This Service Information bulletin supersedes SI 18 02 12 dated May 2012.

Voluntary Emissions Recall Campaign 11E-A03: Check and/or Replace Emissions Monitoring Components

E70 and E90 with the M57Y engine produced from January 2008 to September 2009

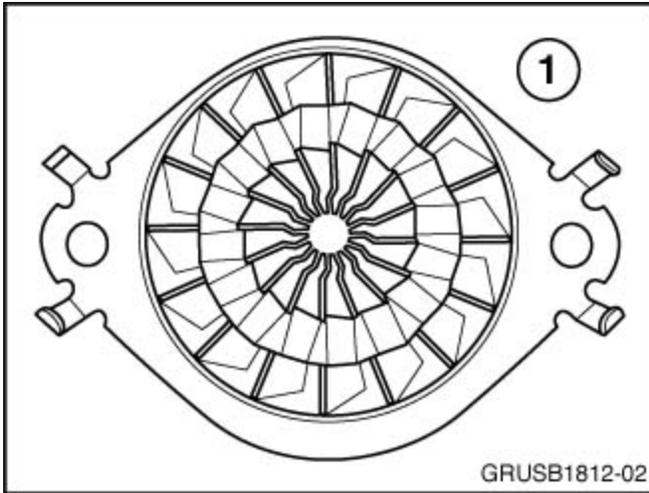
NEW Check the part number of the SCR catalyst (1). If the part number is not 18 30 8 509 752/753 (E70) or 18 30 8 509 749/750 (E90), the SCR catalyst will need to be replaced.

Note: If replacement is necessary, also perform the SCR mixer check/replacement at the same time.

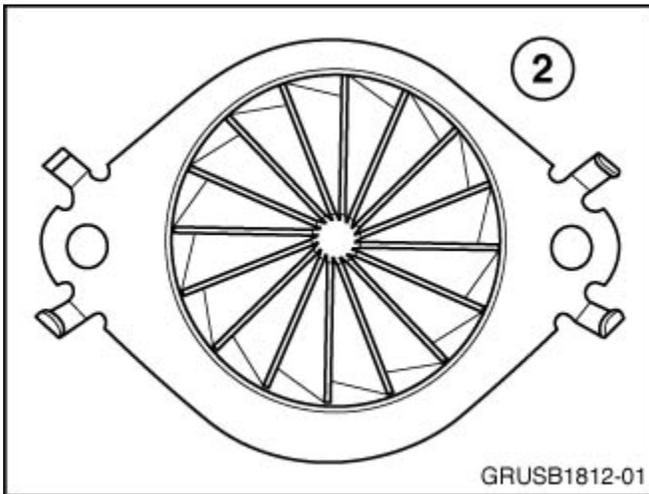
The original style mixer has a multiple fin arrangement (1). This mixer will

need to be replaced with P/N 18 30 8 513 445 (E70) or P/N 18 30 8 512 438 (E90).

If the updated mixer has already been installed, it will have one set of fins (2). No replacement is necessary. Reinstall the SCR front pipe to the down pipe of the DPF.

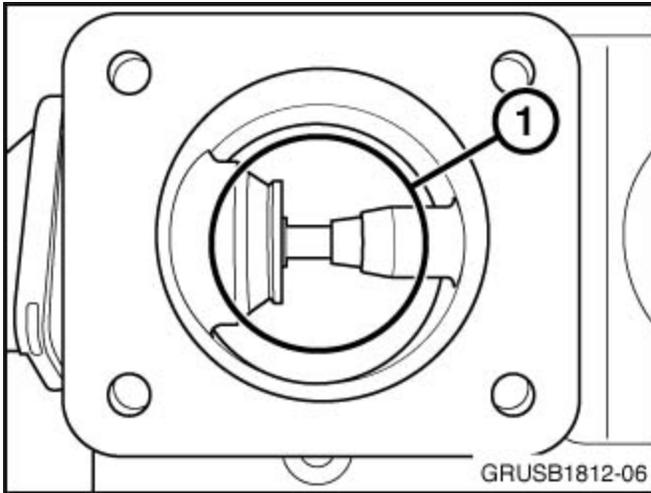
Remove the charge air pipe at the throttle (ignition off). Using a flashlight, look through the throttle (1) and inspect the EGR valve.

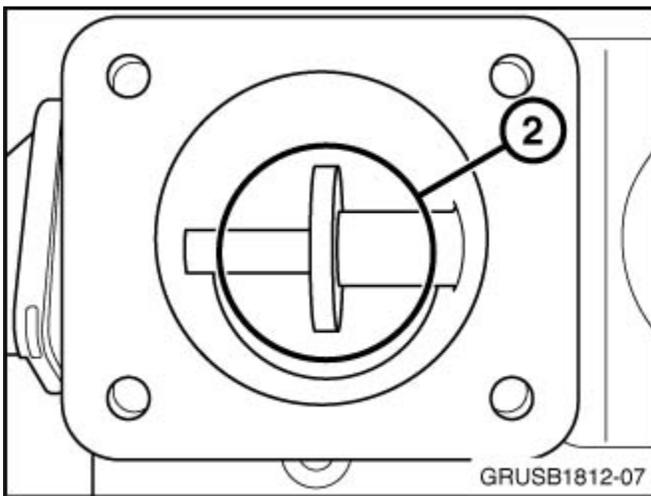
The updated EGR valve (P/N 11 71 8 517 217 or P/N 11 71 8 512 526) has the valve and seat directly in the airstream of the throttle (1). If this valve is installed, no further action is needed. Reinstall the charge air pipe.

The original EGR valve has a diffuser in the airstream flow from the throttle (2). The valve for EGR actuation is seated further into the EGR airstream. Replace this valve with P/N 11 71 8 512 526 (Repair Instruction 11 71 501).

The DDE will also need to be programmed as part of the Recall. If the EGR valve is replaced, the DDE will need to be programmed after the new EGR valve is installed. This new software package contains the necessary software to adapt to the new EGR valve strategy.
